## MEMORANDUM

**TO:** ARCHITECTURAL REVIEW BOARD  
**FROM:** Kate Schwartz, Historic Resources Planner  
**DATE:** May 9, 2016  
**SUBJECT:** Certificate of Appropriateness for exterior alterations at 209 Prince Edward Street

WEST (FRONT) ELEVATION

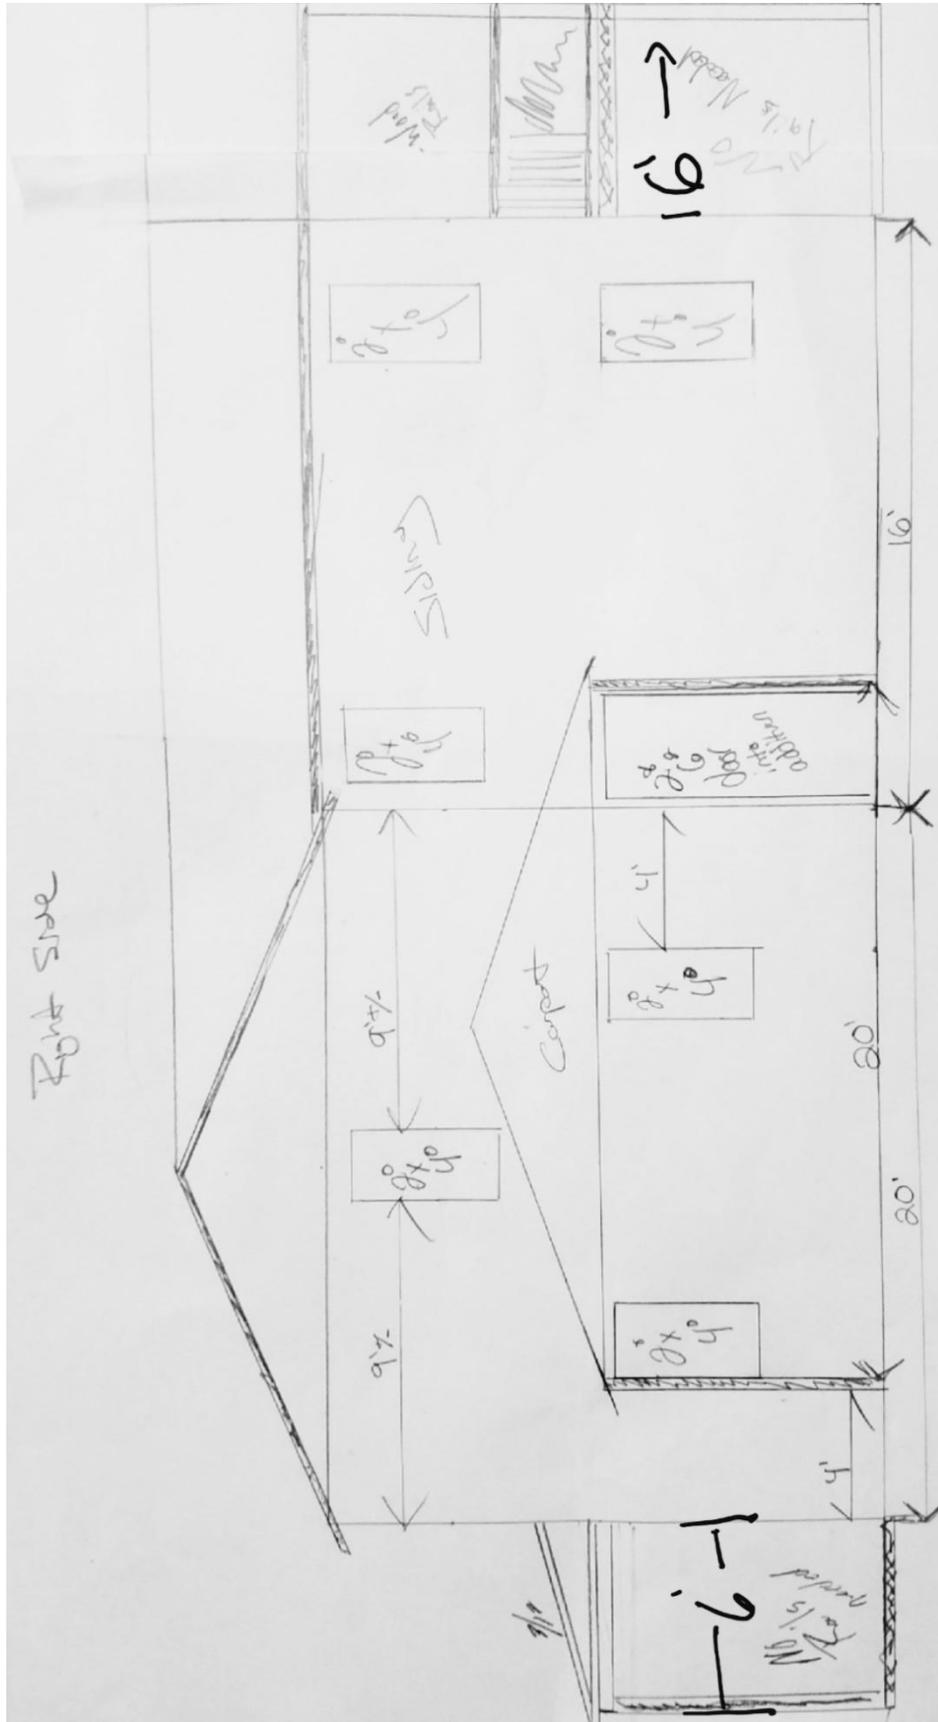
- Replacement of all windows with single or paired six-over-six aluminum or vinyl-clad true divided light windows. The applicant proposes to shift the position of the upper-story windows on the front façade to create a more symmetrical arrangement, with the windows centered over the door and paired window. The applicant also proposes to remove the first floor window on the south elevation, and install two new windows in the same wall. The property file indicates that the windows are not original, but they are exact matches to the original windows. Newer framing appears inside the house, possibly as a result of repairs made after the tree fell on the house, so it is unclear if the windows were ever moved previously.

Removal of the existing wood windows is not recommended. Though the upper-story windows on the front elevation are not centered over the door and paired window below, they are evenly spaced across the upper story. Relocating these windows may accentuate the asymmetry rather than improving the configuration. Rearranging the windows on the side elevation is also not recommended.

- Replacement of the existing front door with a six-panel wood door with glazing in the upper two panels. Staff recommends retaining the existing six-light paneled wood entry door. The existing screen door is a recent alteration and does not appear in photos from 2008. The screen door can be removed without adverse effect.

**1927 Sanborn Fire Insurance Map**  
Note two entry porches at 209 Prince Edward Street.

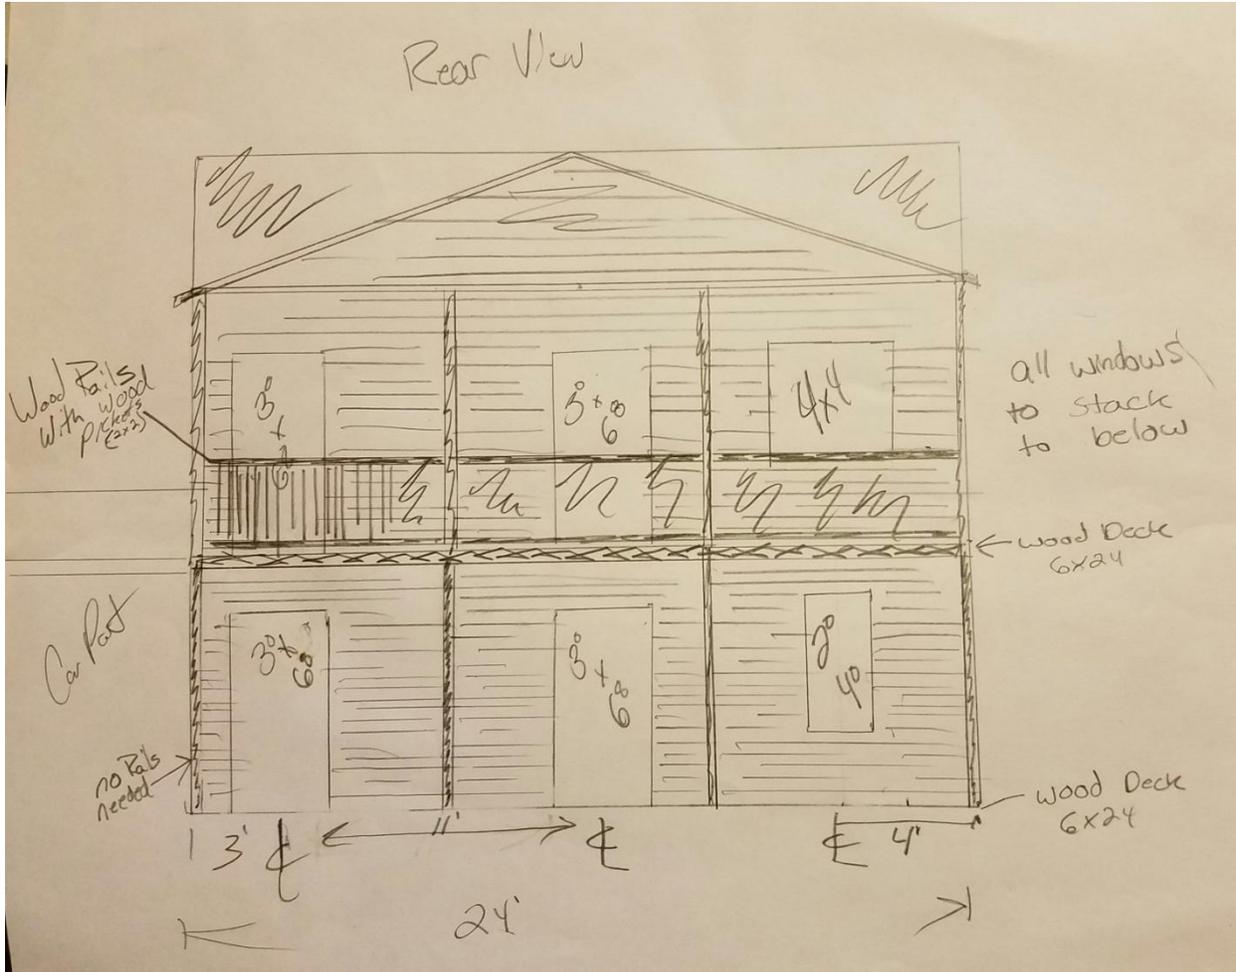
- The existing entry portico and posts will be removed and replaced with a full-width, six-foot deep, shed-roofed porch supported by eight-inch wood posts. The portico appears to be a non-original feature. The 1947 Sanborn Fire Insurance Map shows two one-story entry porches projecting off the front façade. Neither of these matches the existing entry. The proposed porch design aligns with many examples in the surrounding neighborhood and is an appropriate style for the residence and the district.
